ExQ1: 18 March 2026 Responses due by deadline 1: 7 April 2026

21. Water Environment

Diseworth Flood Working Group

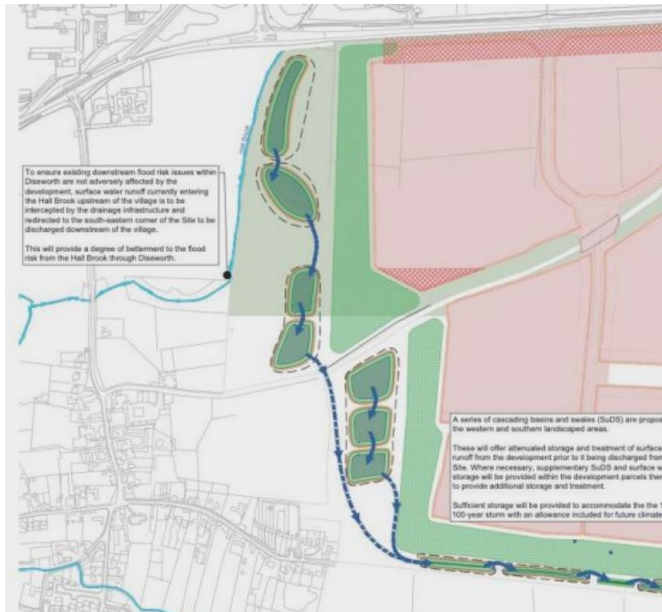
[PD] If connected has proposed capacity of sewerage system, pumping stations and Sewage Treatment Plant at Long Whatton been verified.

[PD] If connected towards Sewage Treatment Plant at Kegworth has capacity of system been verified.

[PD] Has it been confirmed the proposed foul drainage will not be linked or connected to Diseworth's foul drainage system which has combined sewer pipes and manifolds which releases foul water into Hall Brook during storm events?

Segro proposal: EMA release connection to Hall Brook bypass pipe

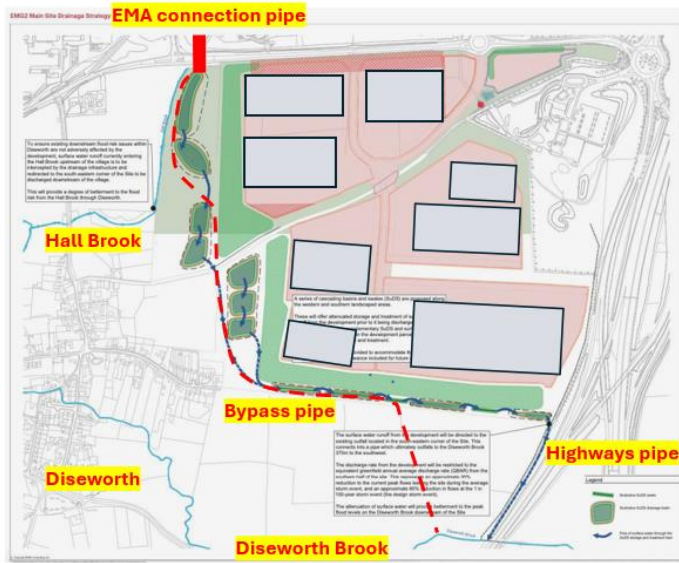
- g. [PD] Diseworth endures property flood damage exacerbated by timing and severity of EA permitted Over Top releases from Airport balancing ponds during low volume storm events as water is released into the Brooks running through the village. As this problem will increase with climate change, and to mitigate cumulative impacts, is the developer able to make provision in plans to accommodate a future diversion pipe?

Divert EMA peak storm release water out of Hall Brook, completely away from Diseworth.

Run EMA bypass pipe around Segro site directly into Diseworth Brook.

No change to site balancing pond or water storage capacity.

No change to site outflow rate into National Highways pipe.
